Re: Correspondence to Wyoming Department of Environmental Quality - Land Quality Division ("WDEQ-LQD") regarding design of Mine Unit I monitor well network.

In response to the Wyoming Department of Environmental Quality - Land Quality Division's (WDEQ-LQD) correspondence of March 3, 1994, Energy Fuels is submitting a description of the planned monitor well network for Mine Unit I at the Reno Creek ISL Project. Enclosed are three geologic cross sections within the monitored area, a Type Log of the Reno Creek Project, plan map of the proposed monitor well network showing both well locations and the index for the geologic cross sections, and a potentiometric surface map based on regional baseline wells for the mineralized portion of the ore sandstone. A summary of the geologic setting, the monitor well completion method, the aquifer properties, the planned monitor well network, the layout for the proposed production authorization pump test are presented for WDEQ's review. Attached at the end of this document are responses to the WDEQ's March 3, 1994 comments regarding approval of the monitor well installation.

FIGURE 10.5-1. LOCATION OF WELL FIELD AND SIMULATED DRAWDOWN GRID.

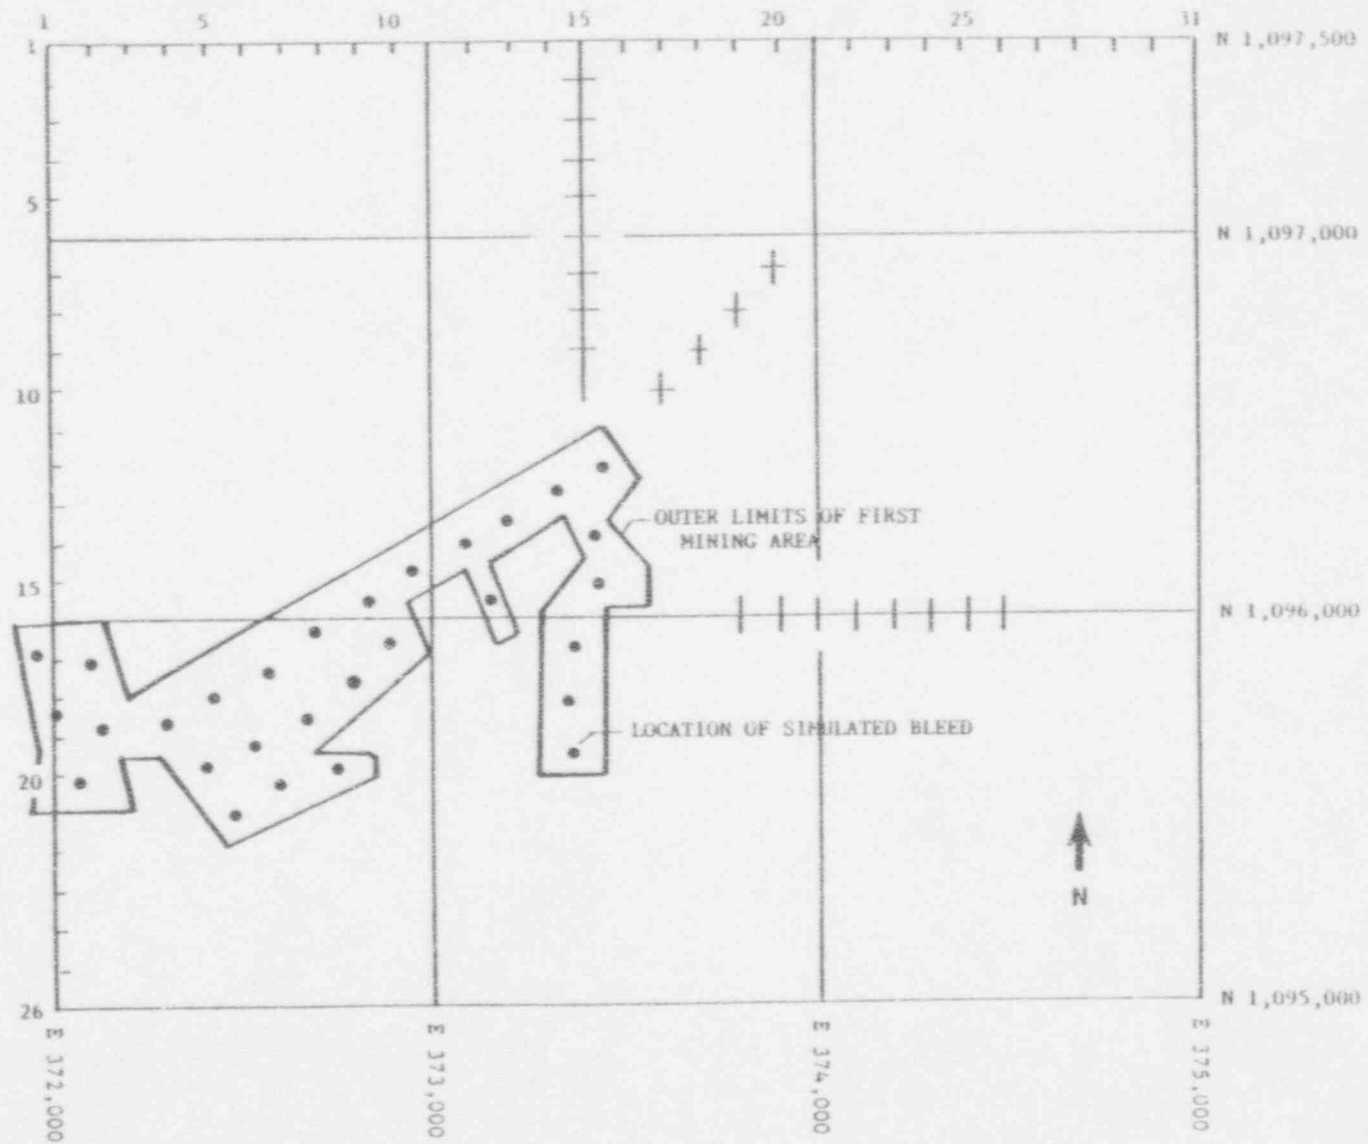
The drawdown calculations for the example consist of 29 pumping (bleed) sites with drawdowns simulated over a 31 by 26 grid. Table 10.5-1 presents the list of input parameters that are initially listed with the output from the WELFLO program. The output listing does not list the first three inputs: enter 1 for printer, enter 1 for non-leaky condition, and enter 1 for fully penetrating wells. Table 10.5-1 presents the remainder of the input data. Table 10.5-2 presents the listing of the simulated drawdowns from the program output for the one percent bleed rate. The wellfield bleed locations are presented in Table 10.5-1 for each of the 29 stresses. The drawdowns east of the center of the wellfield are presented in the number 16 J row from 19 through 24 I columns. Figure 10.5-1 shows the grid used to calculate the drawdown adjacent to Mine Unit I.

FIGURE 10.5-2. DRAWDOWN CHANGES ADJACENT TO MINING UNIT #1.

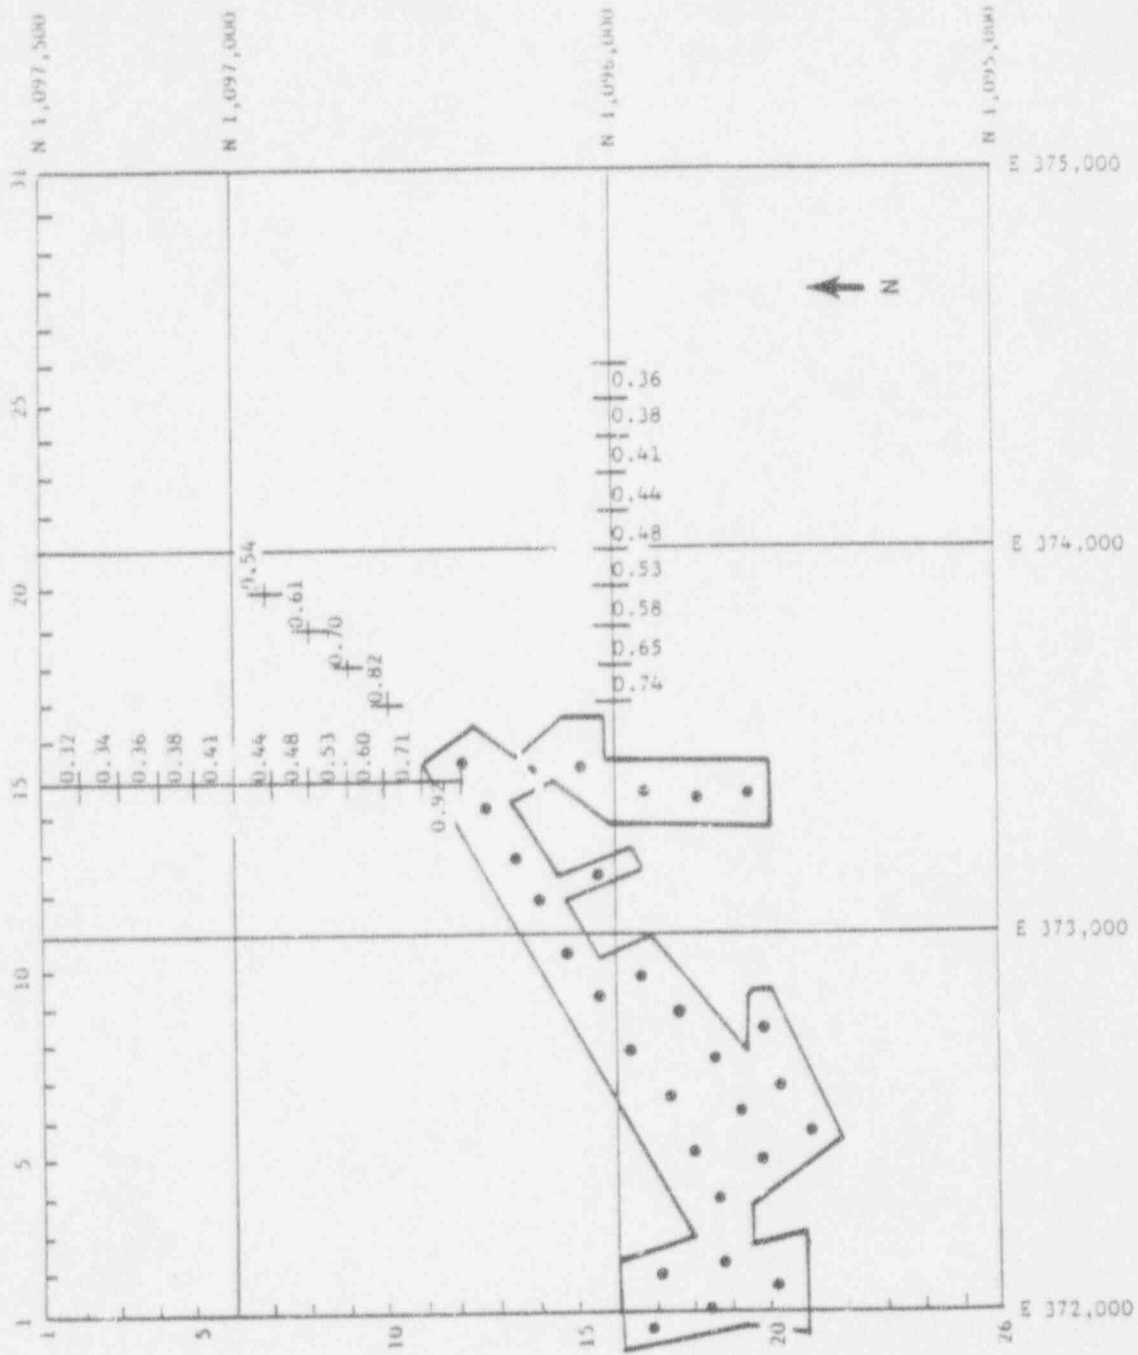
Table 10.5-2 presents the drawdown results for the one percent bleed. Reversal is only established on the northern one of these three lines. Table 10.5-3 gives the drawdown for the two percent bleed simulation while Figure 10.5-2 presents the drawdown changes along these three lines. This

shows that reversal extends out to column 24 along row 16 and beyond row 1 along column 15. It also extends to node (20,7) to the northeast which is approximately 600 feet from the wellfield.

FIGURE 10A-18. DRAWDOWN IN OBSERVATION WELL RI-34.

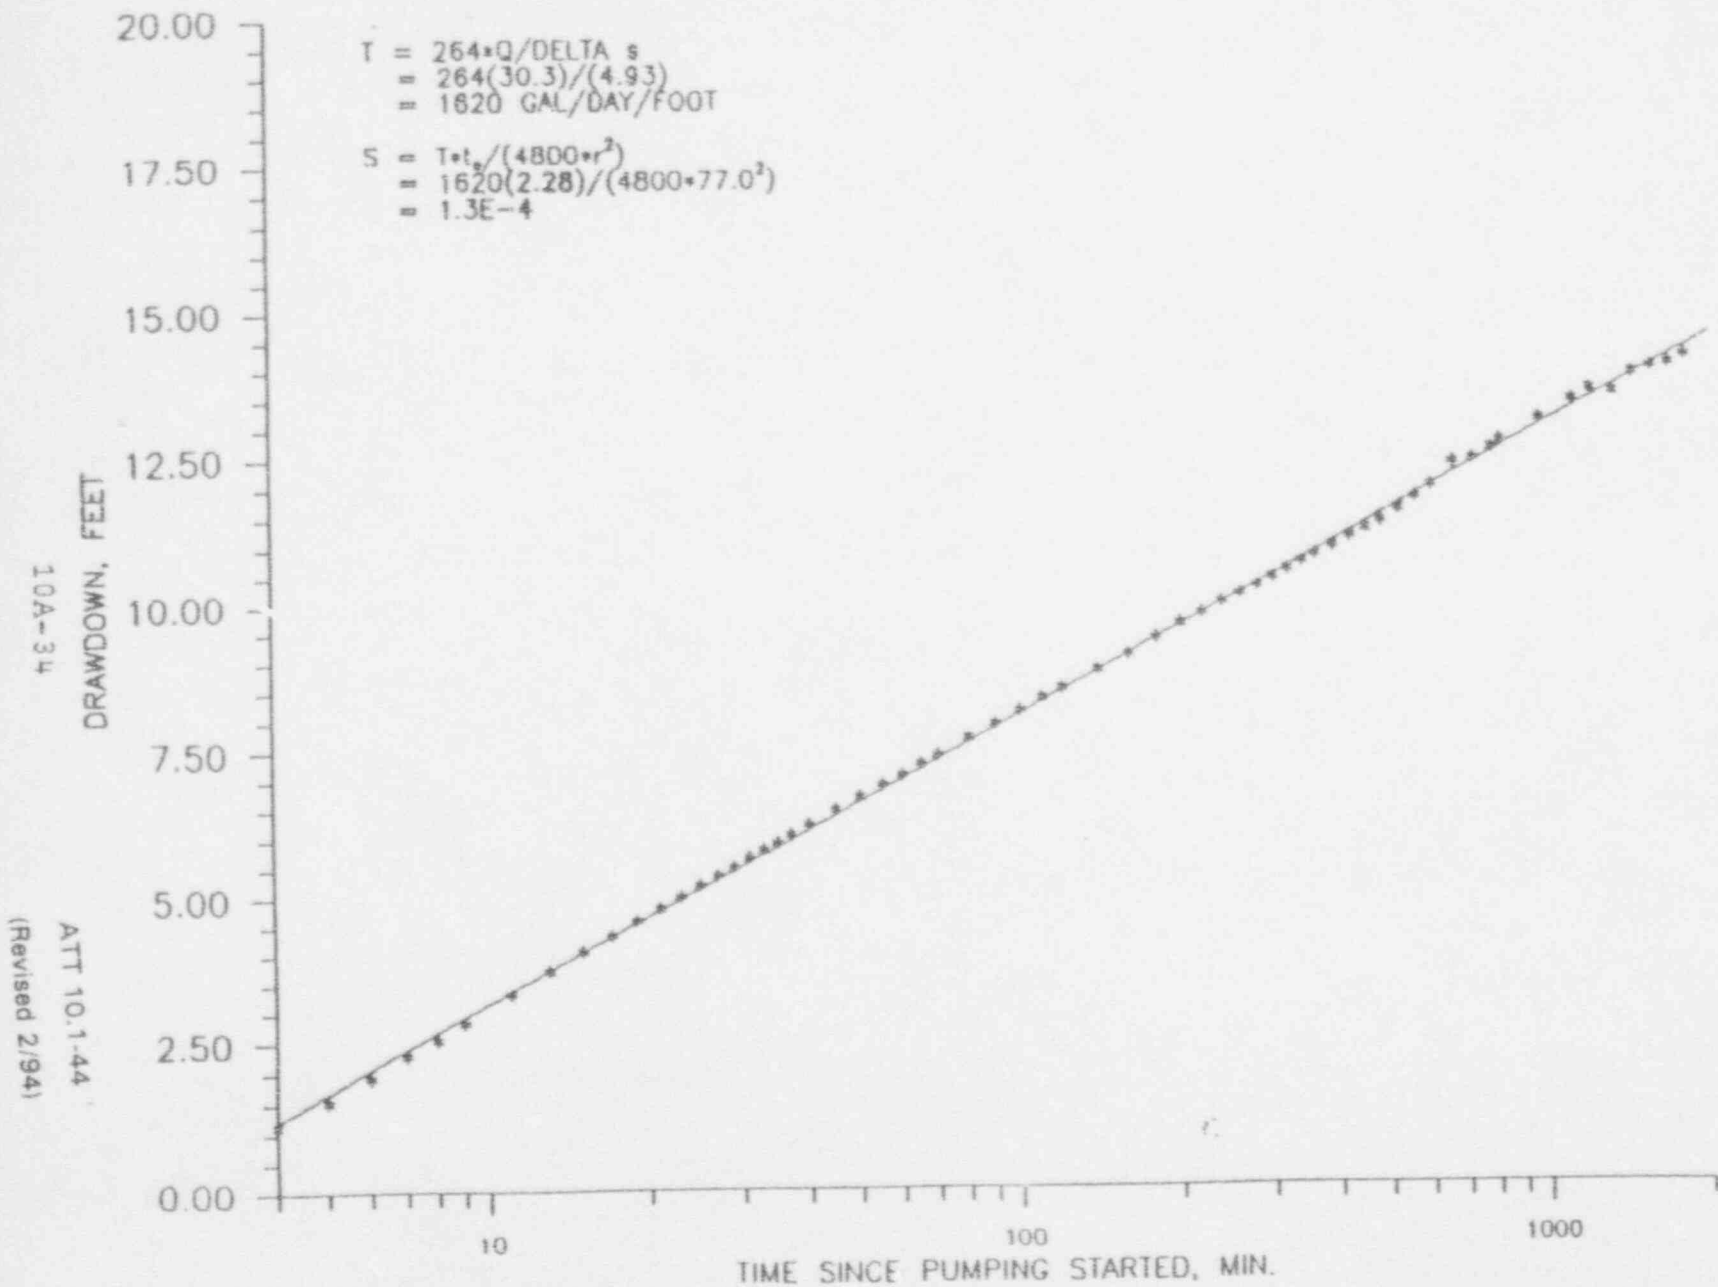
determination should be used. The simulation is for an area within the permit area where aquifer transmissivities are in the intermediate range. A transmissivity of 1600 gal/day/ft and a storage coefficient of 0.00013 are thought to best represent the Ore Sand aquifer in this area. The storage coefficient was obtained from observation well RI-34 (RME test-Figure 10A-18) and is a typical value for the Powder River Basin.

FIGURE 10.5-4. WATER LEVEL CHANGE ALONG A LINE BETWEEN INJECTION AND RECOVERY WELL.

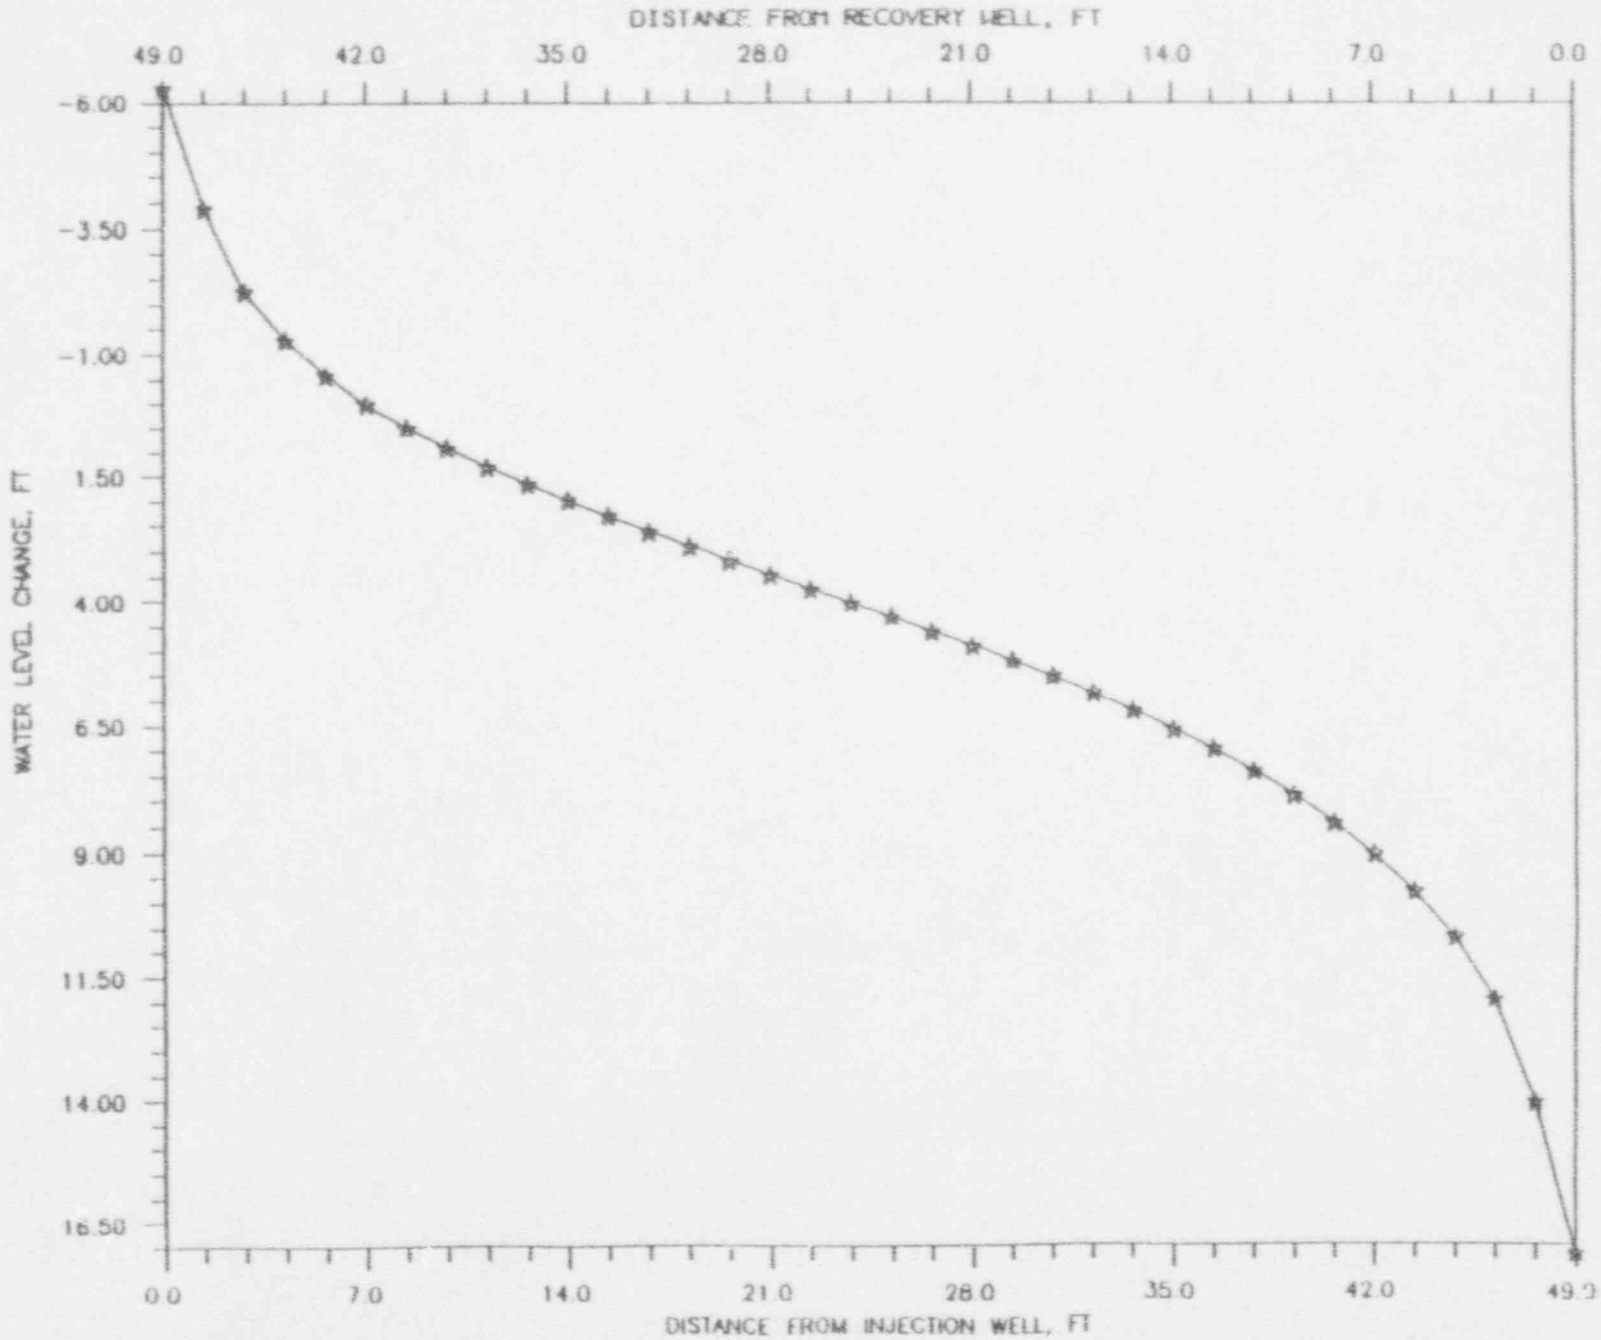
The Ore Sand aquifer is confined in Mine Unit I. The piezometric surface is 19 feet above the top of the Upper Ore Sand and 117 feet above the top of the Lower Ore Sand in this area. The Lower Ore Sand will be mined in Mine Unit I. The injection/ recovery well profile (Figure 10.5-4) demonstrates a maximum drawdown of 17 feet at the recovery well. Therefore, the aquifer will always be in confined conditions in this area.
